Re: CMS Addendum
Phase II Corrective Measures Study
Olin Buffalo Avenue Plant

**NYSDEC AND USEPA COMMENTS ON THE
PHASE II CORRECTIVE MEASURES STUDY
(LETTER DATED JUNE 5, 1995)**

Re: Phase II Corrective Measures Study
Olin Buffalo Avenue Plant

Figure 4-6
SIGNIFICANT VOLATILES AND SEMIVOLATILES
IN COMPOSITE SOIL SAMPLES (6.0' TO BEDROCK)

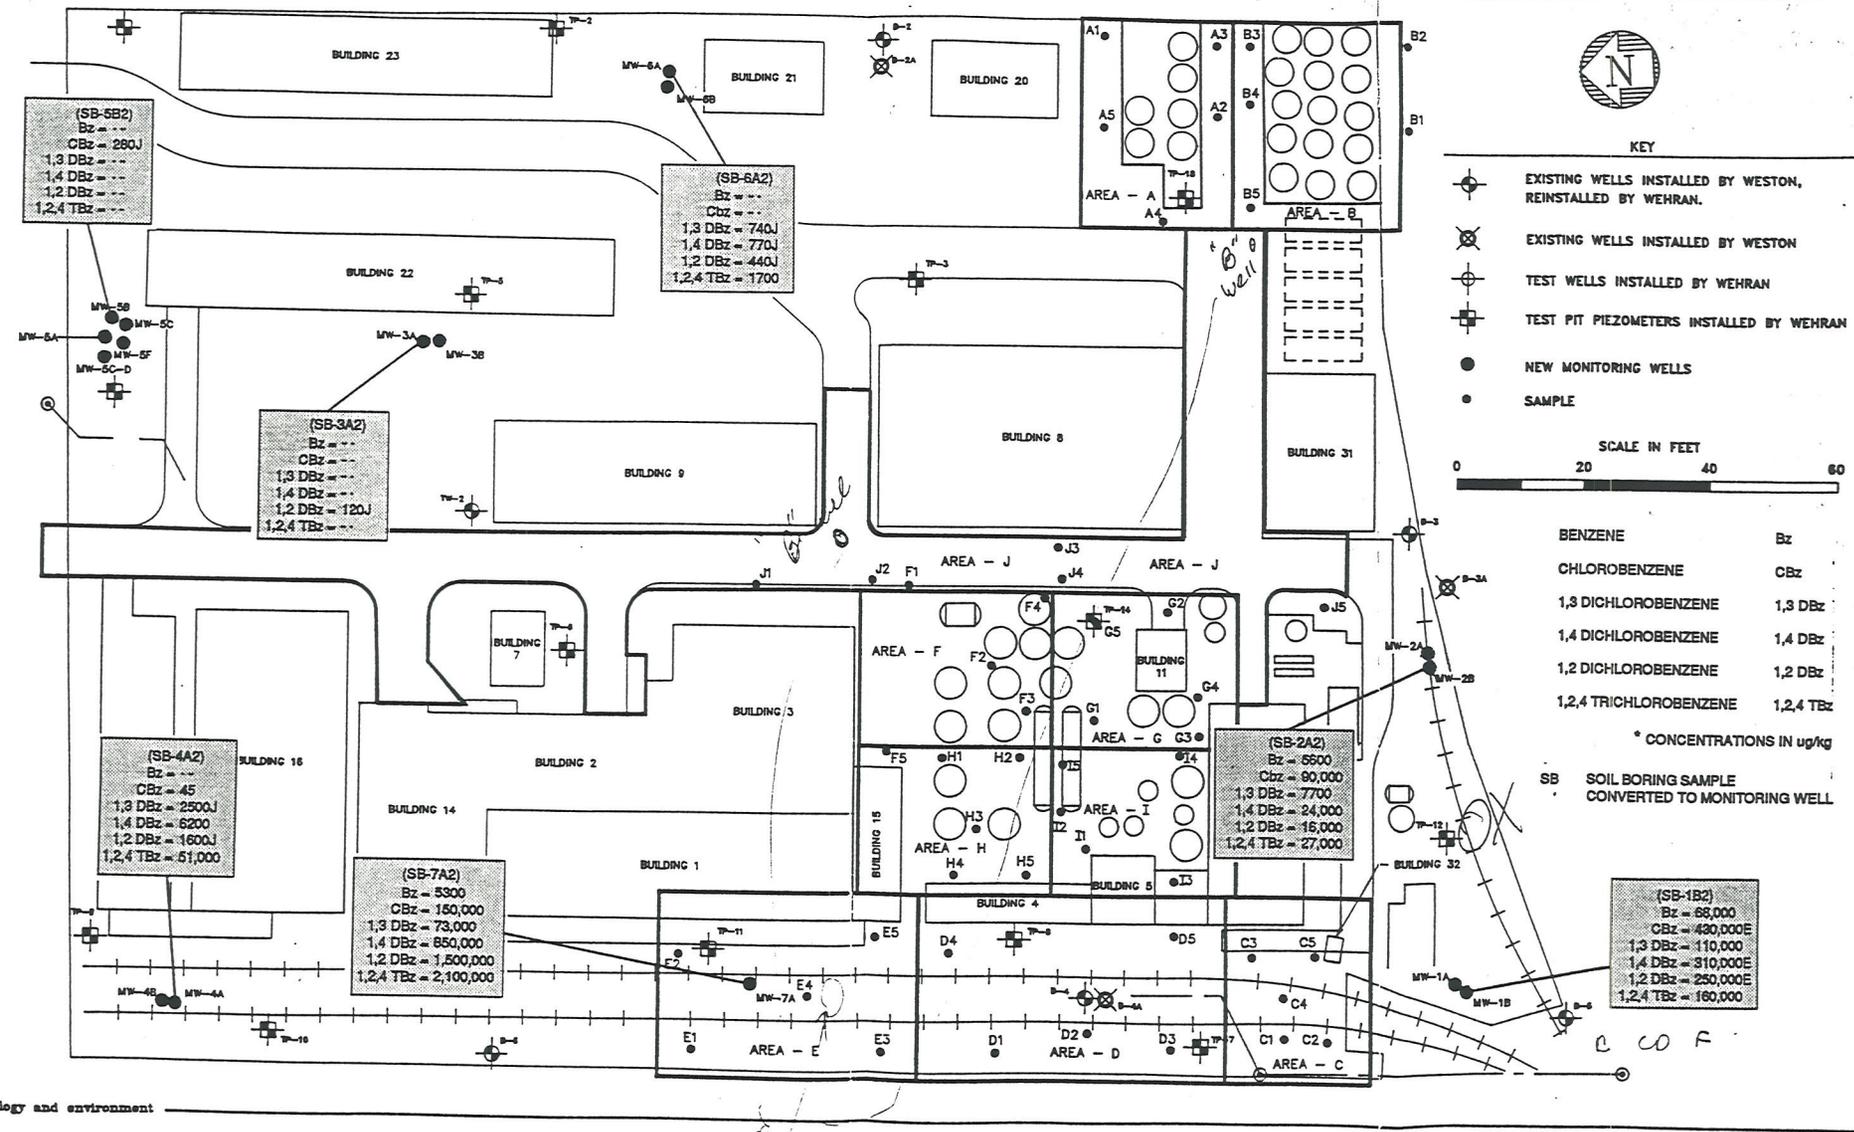
We also question the current usefulness of benzene ratios as a mechanism for determining the source(s) of the observed contamination. As can be seen by comparing the attached Figure 4-6 and Figure 4-7 (Significant Volatiles and Semivolatiles in Composite Soil Samples)¹, with the Solvent Chemical groundwater data which Olin used in Figures 8-1 through 8-6 of the CMS, there appears to be a significant disparity between the abundance of 1,2,4-trichlorobenzene in the Solvent Chemical soils and its concentration in the groundwater. It is possible that differences in the solubility and the degree of transport retardation among the various chlorinated benzenes may affect the ratios of the compounds as they migrate from their respective sources. A more detailed analysis of these issues, including the collection of additional data would be needed to support decisions based upon the use of benzene ratios.

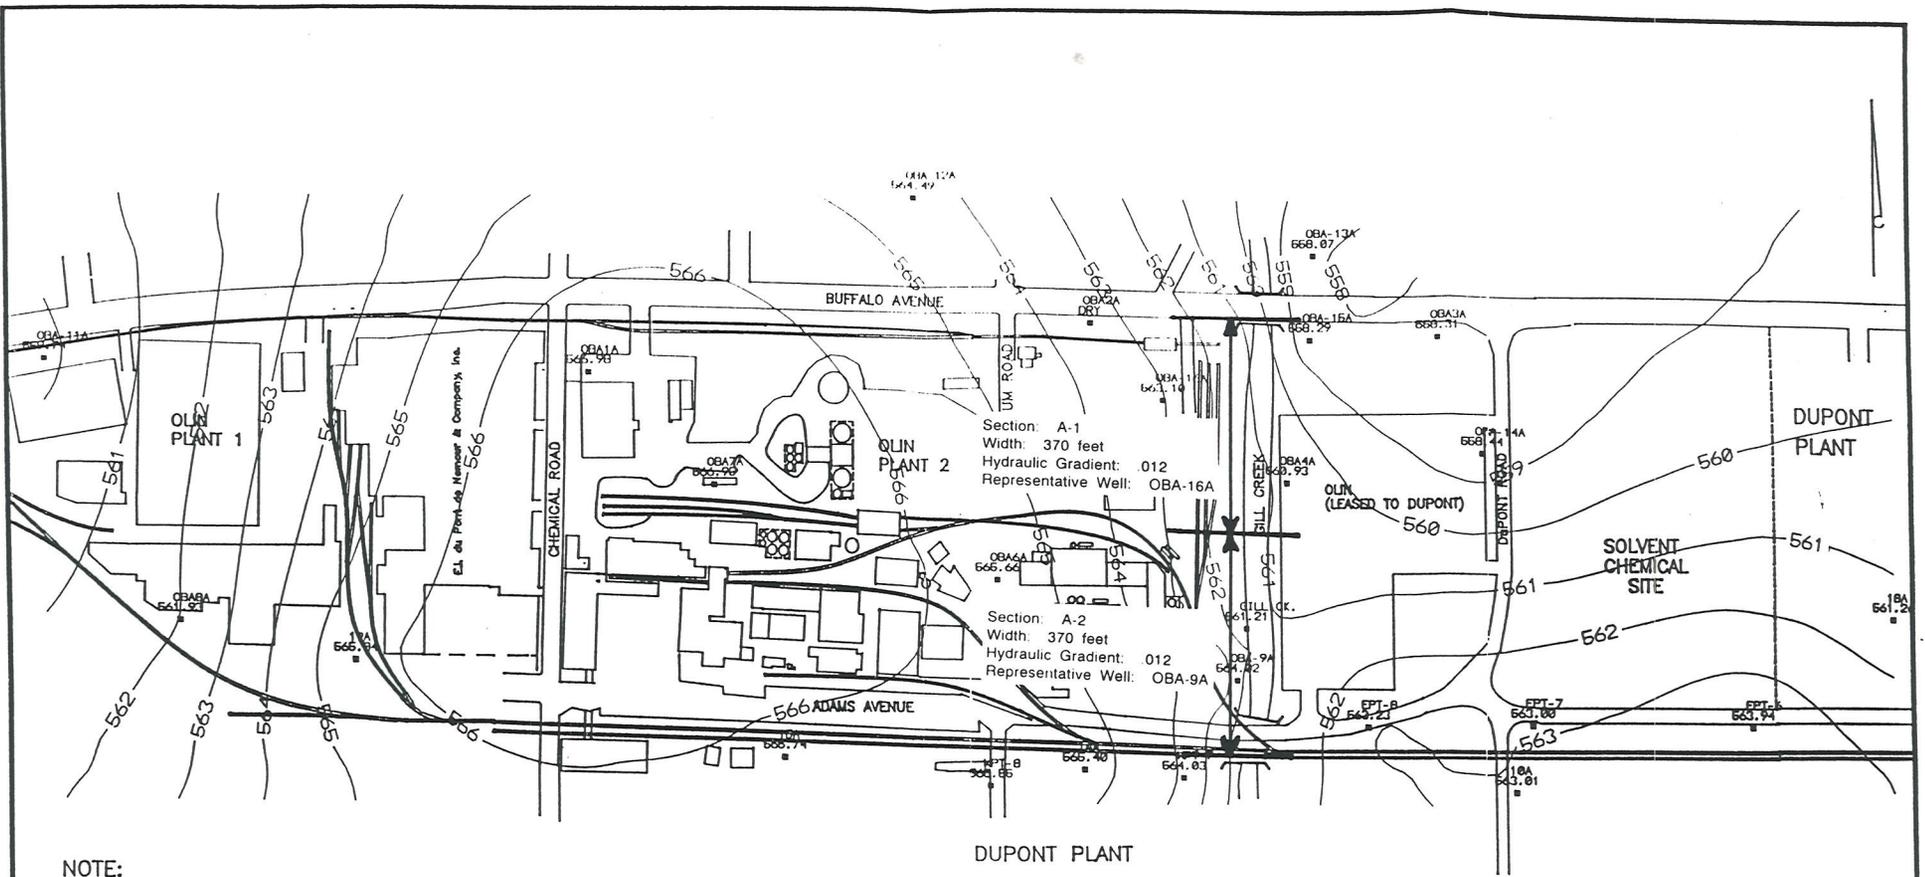
1. The Agencies agree with Olin's conclusions that the sewers along Buffalo Avenue and the East side of Gill Creek appear to be intercepting groundwater flow in the A and B Zones. As part of the CMS, Olin must evaluate the environmental impacts associated with groundwater infiltration into the Buffalo Avenue Sewers. (What is the contaminant loading to the sewer and where do the sewers discharge?)

1. Olin agrees to assess contaminant loading from the Buffalo Avenue Plant to the Buffalo Avenue sewers and the sewer along the east side of Gill Creek. Based on our information, the Buffalo Avenue diversion sewer discharges to the Niagara River without treatment and the Buffalo Avenue sanitary sewer and the sewer along the east side of Gill Creek discharge to the Niagara Falls Wastewater Treatment Plant. The results of this assessment are included as Attachment II.

Zone groundwater flow toward the DuPont Sanitary Sewer occurs between Adams Avenue and Buffalo Avenue. For purposes of flow estimation, this was divided into two flow sections (designated A-1 and A-2) as shown on Figure 1, a typical A-Zone piezometric gradient map, which has been adapted from the RFI.

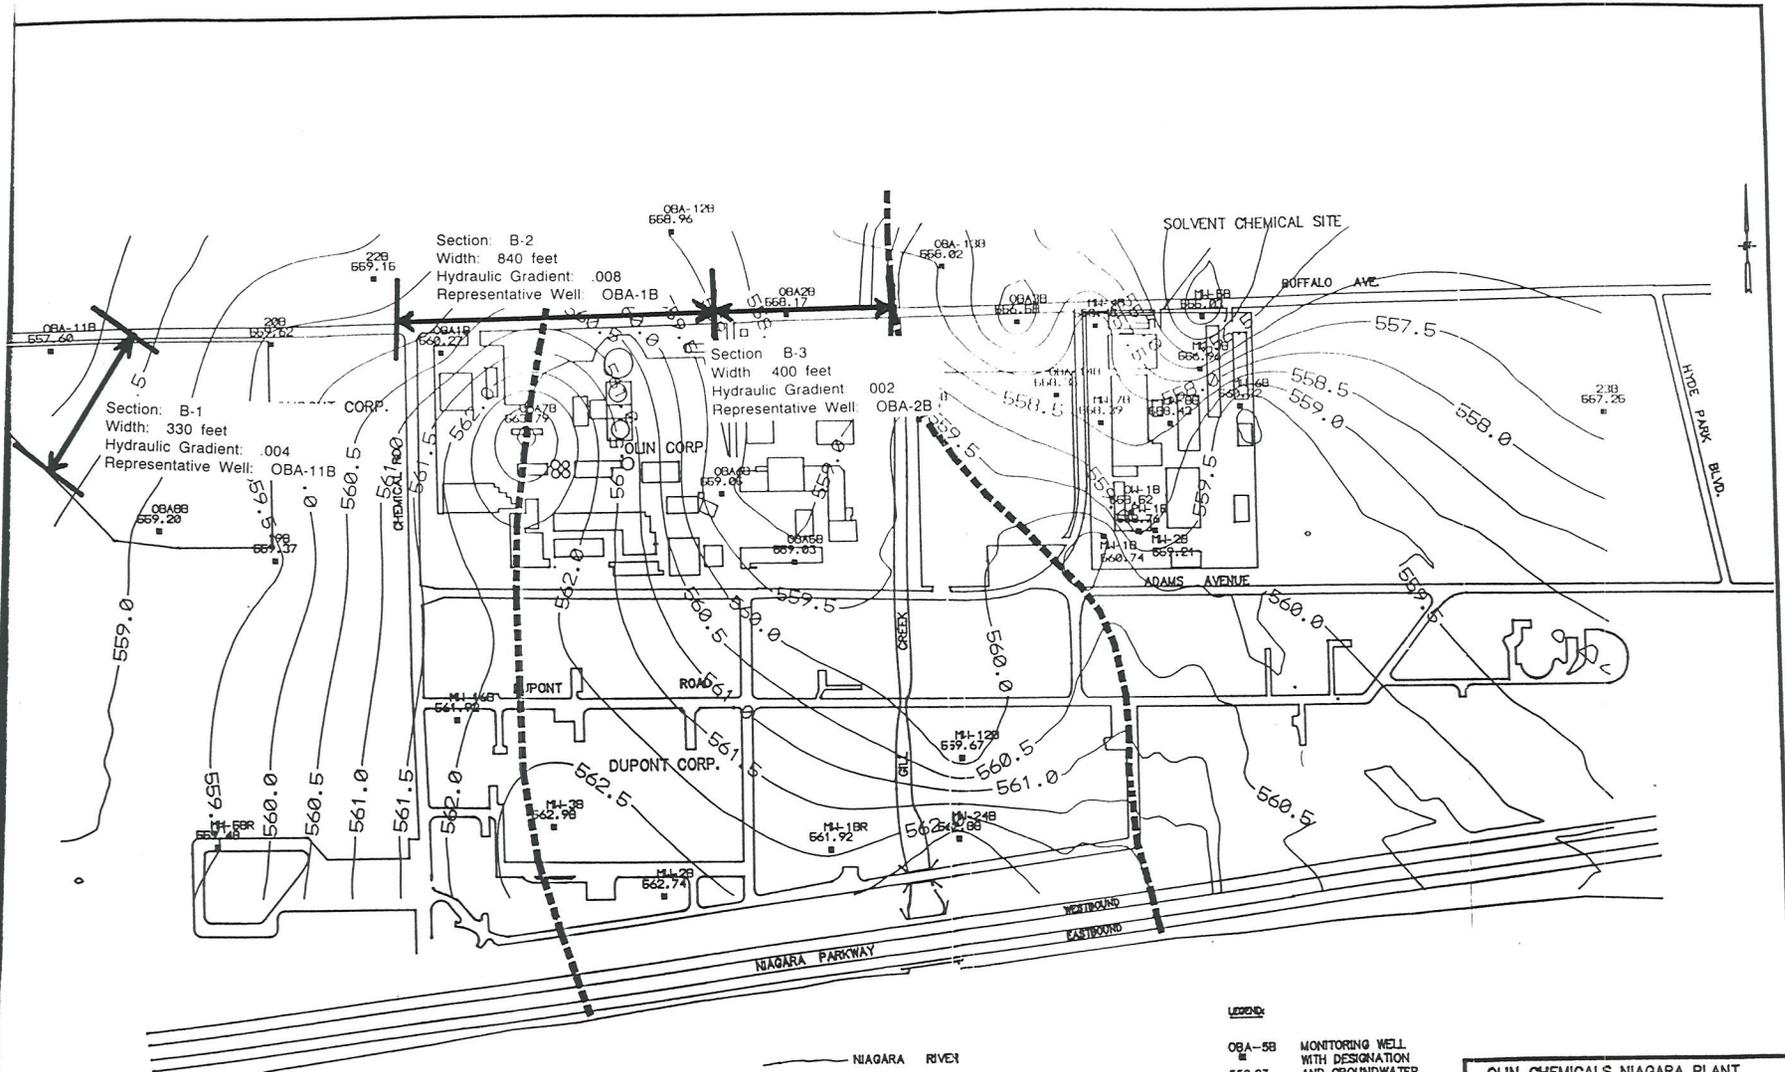
2. Figure 3.2 should be revised to reflect the assumed discharge of groundwater into the sewers.
3. If OBA-11A was dry, as stated on page 12 of the report and if OBA-18A was dry, as stated on page 15 of the report, why does Figure 3.2 include groundwater elevation data, 561.07 ft and 560.66 ft, respectively, from the wells? Furthermore, the stated water level elevation for OBA-18A is more than two feet beneath the base of the well (562.95) as described in the well log in Appendix A.

2. Figure 3.2 does not require revision given the dewatered conditions in the A-Zone near Buffalo Avenue. ✓
3. The bedrock completion data for monitoring wells OBA-18A and OBA-19A were presented in the CMS on a separate page from the overburden data. The bedrock data for the wells is attached for your information (Attachment III). ✓

The A-Zone is dewatered in the vicinity of the Buffalo Avenue Sewers. Therefore groundwater discharge to the sewers occurs through the B-Zone. The B-Zone potentiometric surface map presented on Figure 2 indicates groundwater flow toward the Buffalo Avenue sewers occurs along Buffalo Avenue between Gill Creek and Chemical Road (Plant 2) and across the northwest portion of Plant 1. For purposes of flow estimation, these areas were divided into three flow sections (designated B-1, B-2 and B-3) as shown on Figure 2, a typical B-Zone piezometric map, which has been adapted from the RFI.
